HIGHCREST — connection

providing a multi-use path for bikers and pedestrians

Proposed Path

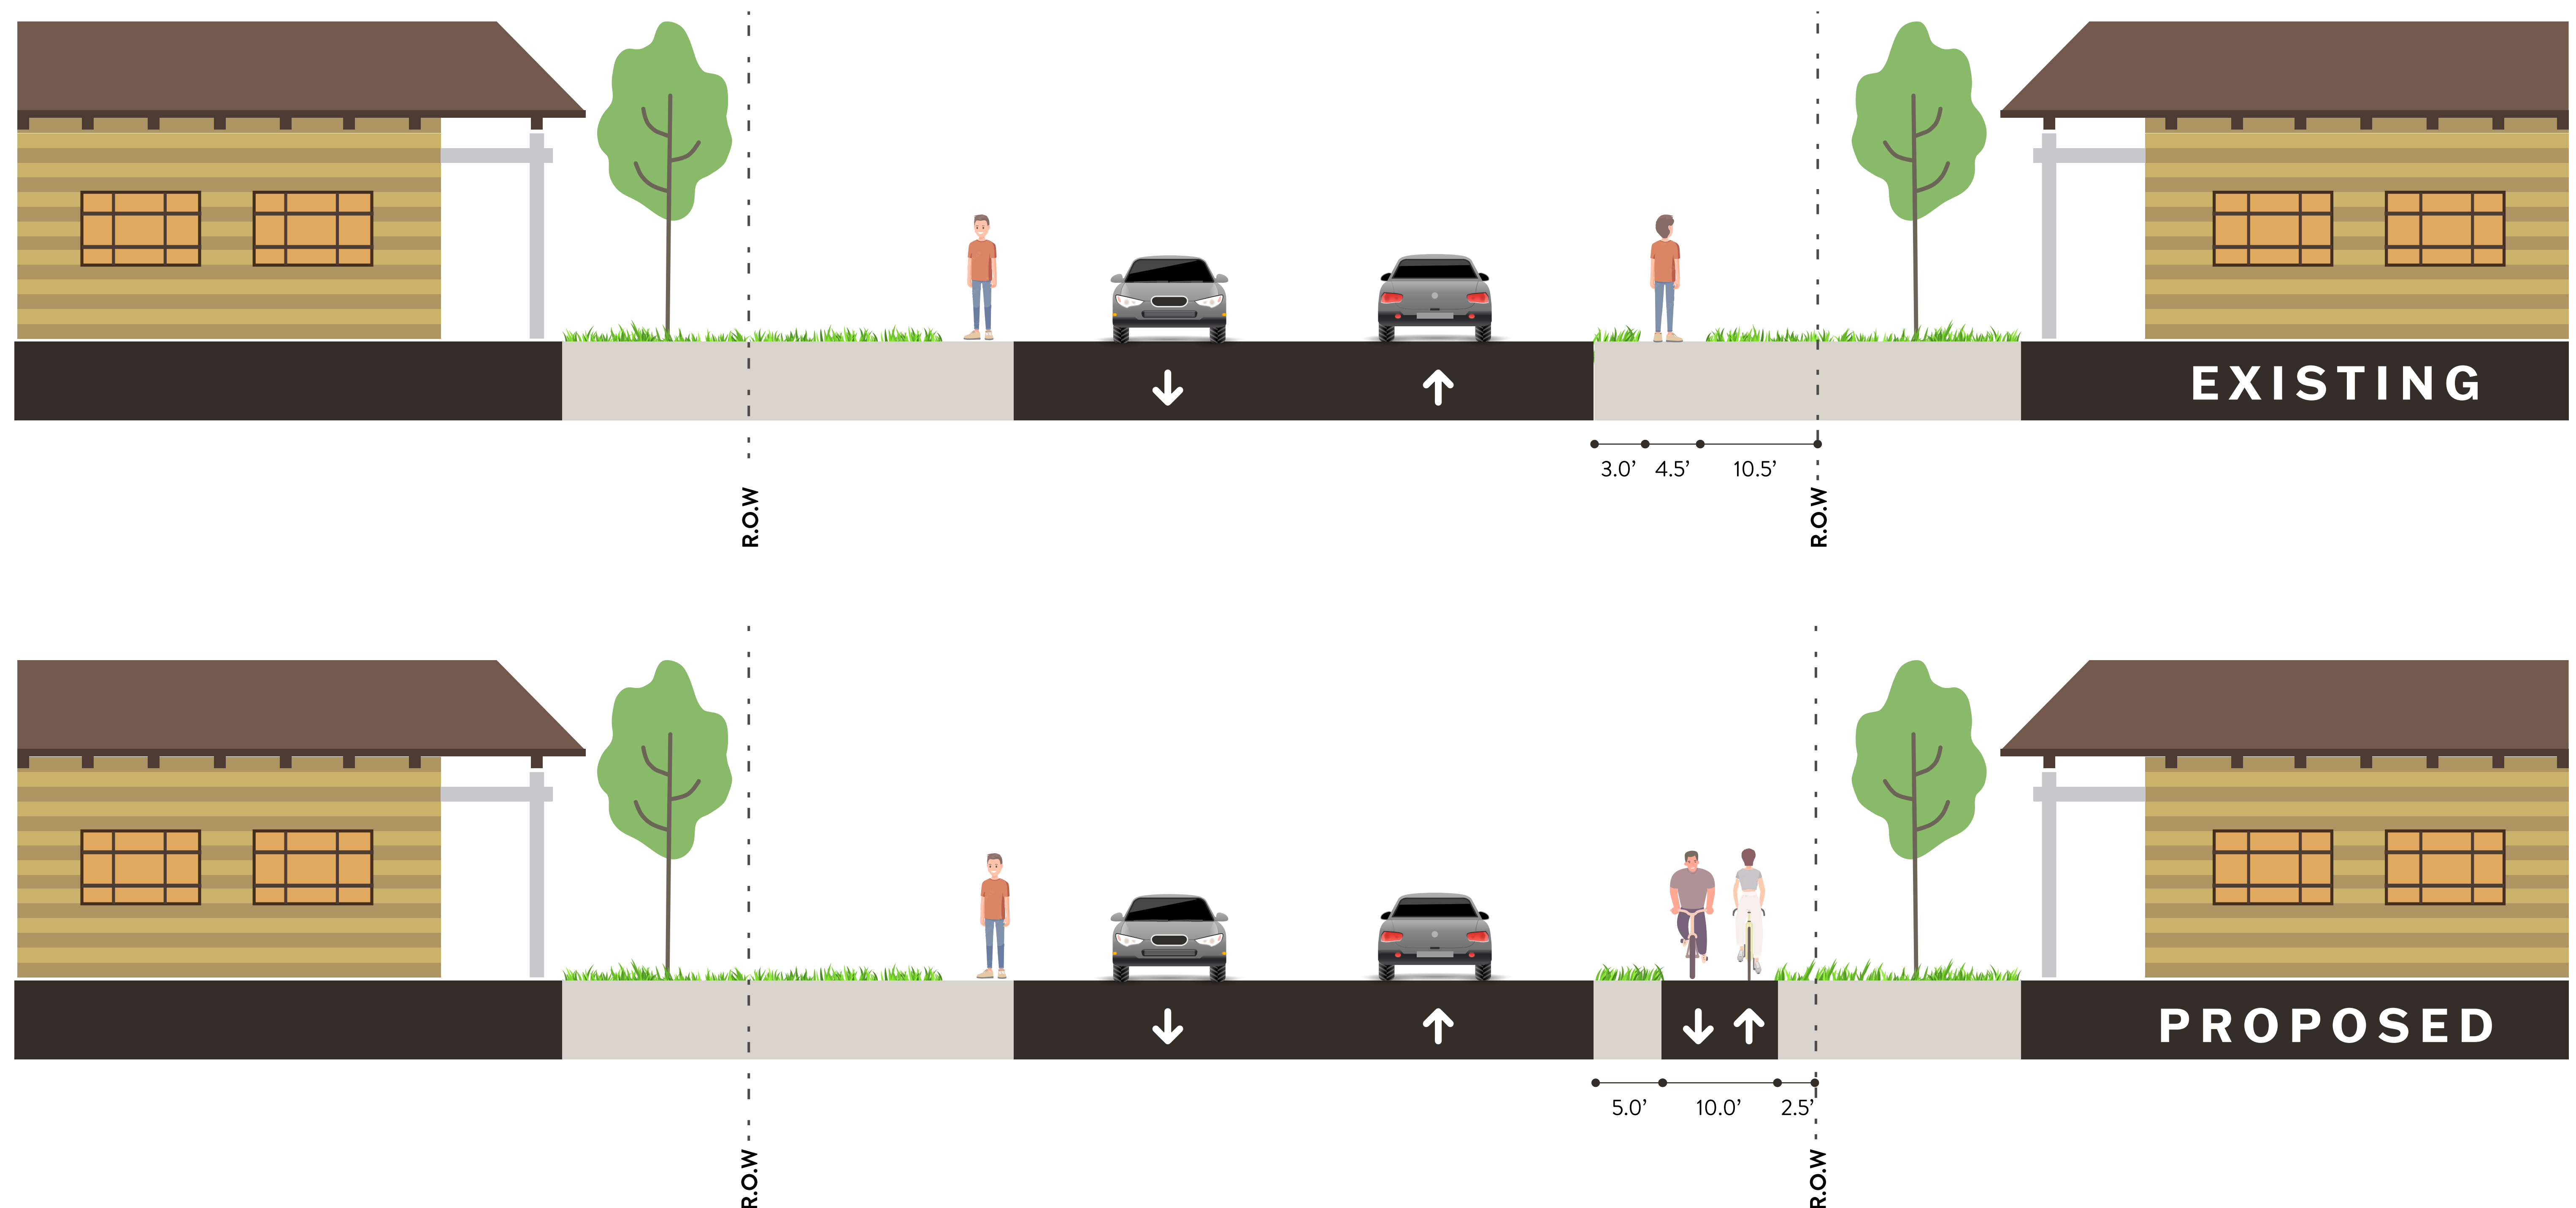
? “I am worried about the loss of privacy since this is too close to my house”. —ROCKFORD RESIDENT

? “Can the MUP be rerouted within the right-of-way at the SW corner of Highcrest & Spring Creek to create a more straight-through path to the Parkview intersection?” —ROCKFORD RESIDENT

A The proposed improvement includes 5' of green space between the existing back of curb and then 10' of multi-use path. Efforts have been made to keep the new path on public ROW, generally where the existing sidewalk is located.

A Great suggestion, we will look to incorporate that change into our construction plans if the project moves forward.
